## dsPIC33EPXXGS50X Family Silicon Errata and Data Sheet Clarification

The dsPIC33EPXXGS50X family devices that you have received conform functionally to the current Device Data Sheet (DS70005127D), except for the anomalies described in this document.

**FIGURE 1: EXAMPLE FOR REDUNDANT OUTPUT MODE**

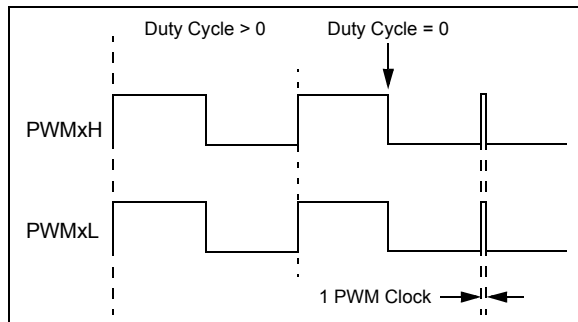
In the Redundant Output mode (IOCONx[11:10] = 0b01) and Push-Pull Output mode (IOCONx[11:10] = 0b10), with the Immediate Update Enable bit disabled (PWMCONx[0] = 0), when the Duty Cycle register is updated from a non-zero value to zero, a glitch pulse of a width equal to one PWM clock will appear at the next PWM period boundary, as shown in Figure 1 (for the Redundant Output mode). The Duty Cycle register refers to the PDCx register if PWMCONx[8] = 0 or the MDC register if PWMCONx[8] = 1.

If the application requires a zero duty cycle output, there are two possible work around methods:

1. Use the PWM override feature to override the PWM output to a low state instead of writing to the Duty Cycle register. In order to switch back to a non-zero duty cycle output, turn off the PWM override. The override-on and override-off events must be timed close to the PWM period boundary if the IOCONx register has been configured with IOCONx[0] = 0 (i.e., output overrides through the OVDDAT[1:0] bits occur on the next CPU clock boundary).
2. Enable the Immediate Update Enable bit (PWMCONx[0] = 1) while configuring the PWMx module (i.e., before enabling the PWMx module, PTCON[15] = 1). With the Immediate Update enabled, writes to the Duty Cycle register can have an immediate effect on the PWM output. Therefore, the duty cycle write operations must be timed close to the PWM period boundary in order to avoid distortions in the PWM output.

FIGURE 2:

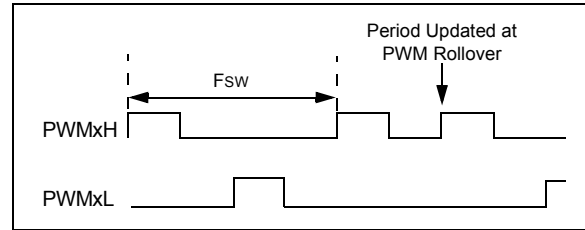
When the PWM module is configured for Push-Pull mode (IOCONx[11:10] = 0b10) with the Enable Immediate Period Update bit enabled (PTCON[10] = 1), a write to the Period register that coincides with the period rollover event may cause the push-pull output logic to produce back-to-back pulses on the PWMx pins (Figure 2).

Ensure that the update to the PWM Period register occurs away from the PWM rollover event by setting the EIPU bit (PTCON[10] = 1). Use either the PWM Special Event Trigger (SEVTCMP) or the PWM Primary Trigger (TRIGx) to generate a PWM Interrupt Service Routine (ISR) near the start of the PWM cycle. This ISR will ensure that period writes do not occur near the PWM period rollover event.

**FIGURE 3: MISMATCH OF WORKING REGISTER SET WHEN NESTING MORE THAN ONE INTERRUPT WITHIN INTERRUPTS THAT USE ALTERNATE WORKING REGISTER SETS**

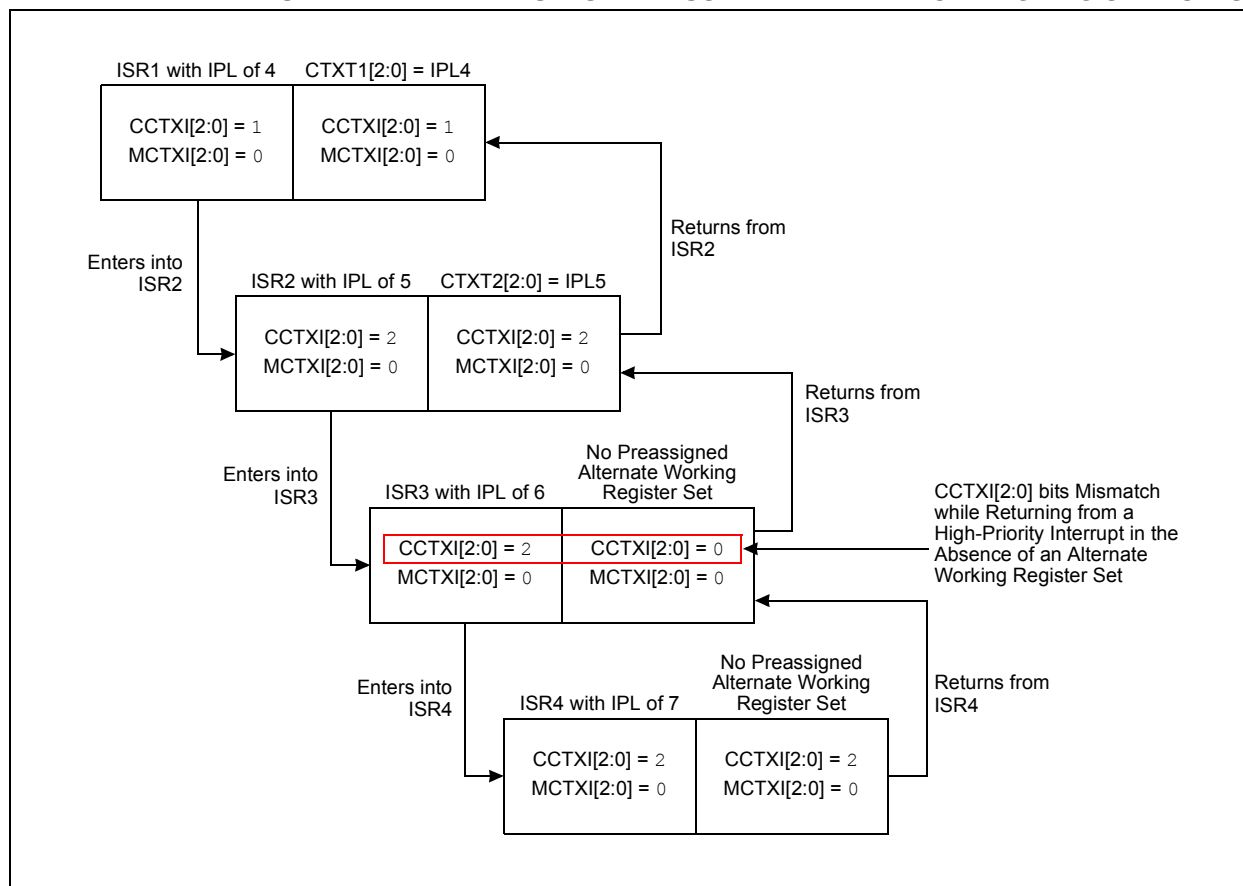
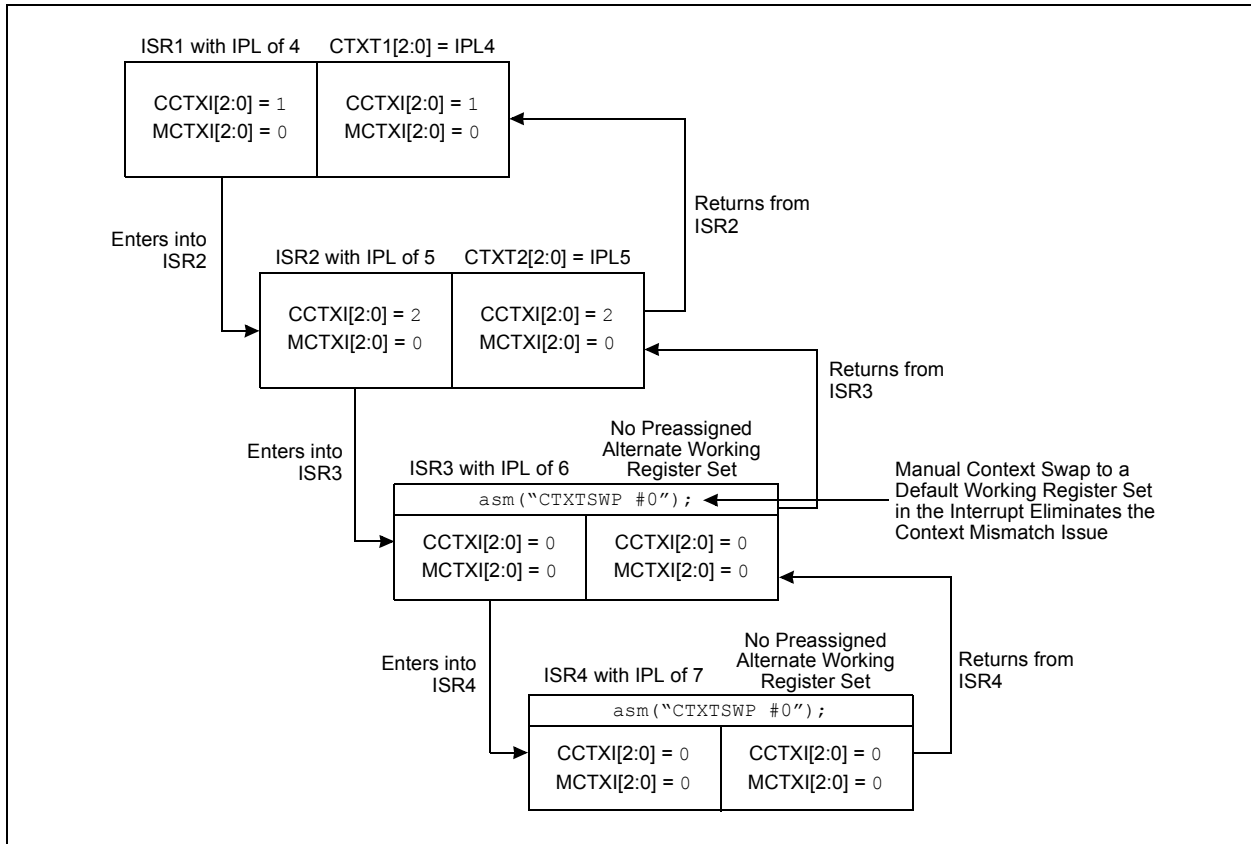
When returning from an Interrupt Service Routine (ISR) by executing the `RETFIE` instruction, in the case of a nested interrupt, the Interrupt Priority Control bits (`IPC[3:0]`) associated with the lower priority interrupt are compared with the `CTXTn` bits field in the `FLTREG` Configuration register:

When using interrupts with the Alternate Working Register Set (automatic context assignment), no more than one ISR without an Alternate Working Register Set must be nested within an ISR with an Alternate Working Register Set.

Issue and work around are illustrated in [Figure 3](#) and [Figure 4](#), respectively. The figures show the status bits, `CCTXI[2:0]` and `MCTXI[2:0]`, after entering into an ISR from a lower priority ISR (left pane), and after returning to the same ISR from a higher priority ISR (right pane).

**Work around 1:** When using interrupts with the Alternate Working Register Set, at the entry of all ISRs that do not have an Alternate Working Register Set and have a higher IPL level than the ISRs with an Alternate Working Register Set, perform a manual context swap to Context #0 as:

**Work around 2:** Always assign higher IPLs for the ISRs that use an Alternate Working Register Set than for the ISRs that do not use an Alternate Working Register Set.

**FIGURE 5: SIMPLIFIED BEHAVIOR**

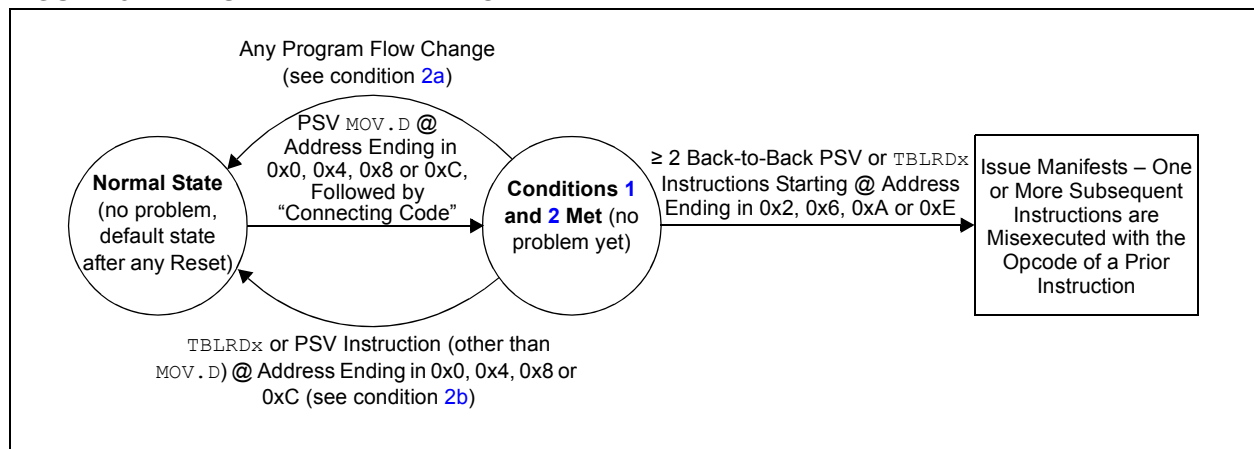
When two or more data Flash read instructions (via Program Space Visibility (PSV) read or table read) are executed back-to-back, one or more subsequent instructions can be misexecuted when all of the conditions in [Table 5](#) occur.

[Figure 5](#) provides an example of the effective behavior.

1. All instances of PSV `MOV.D` can be replaced with two PSV `MOV` instructions instead. Non-PSV `MOV.D` instructions acting on RAM/SFRs do not need to be modified; or
2. If not already present, a program flow change instruction (such as `BRA $+2`) can be inserted above back-to-back data Flash read sequences; or
3. Back-to-back data Flash read instruction sequences can be broken up by inserting a non-Flash read instruction (such as a `NOP`), in between the Flash read instructions; or
4. The alignment of the code can be shifted to avoid the required opcode location addresses.
